FINAL FINDINGS AND DECISION BY THE DESIGN COMMISSION RENDERED ON January 15, 2015

CASE FILE NUMBER: LU 14-220722 DZ AD
PC #14-214725

TESS O'BRIEN APARTMENTS

LU 14-220722-2 EX. C-31

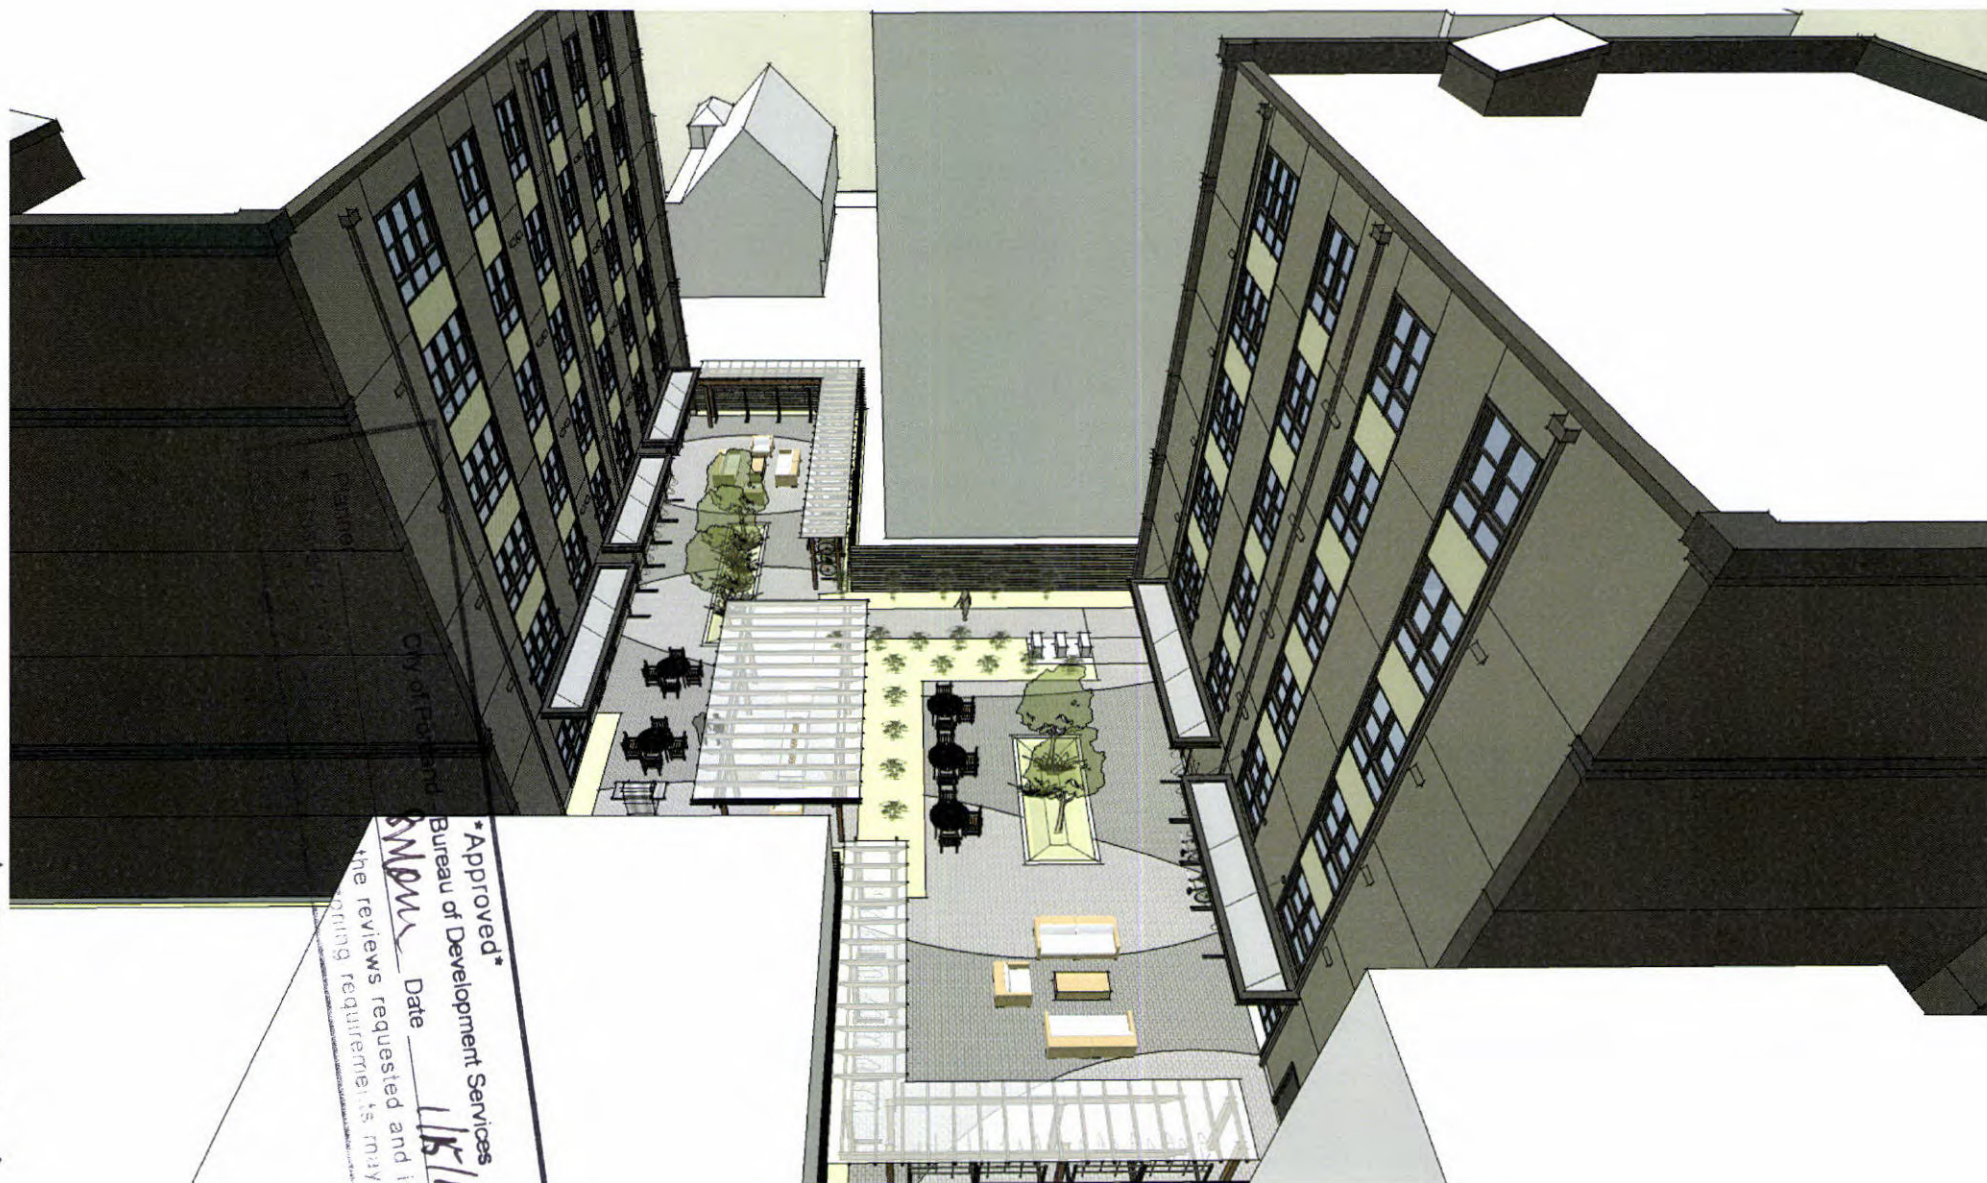
- D.** The canopies along the ground level of both buildings that face the courtyard must match the design and materials of the steel canopies on the street-facades of both buildings as shown in detail A3 of Exhibit C.21 and as depicted on Exhibit C.31.
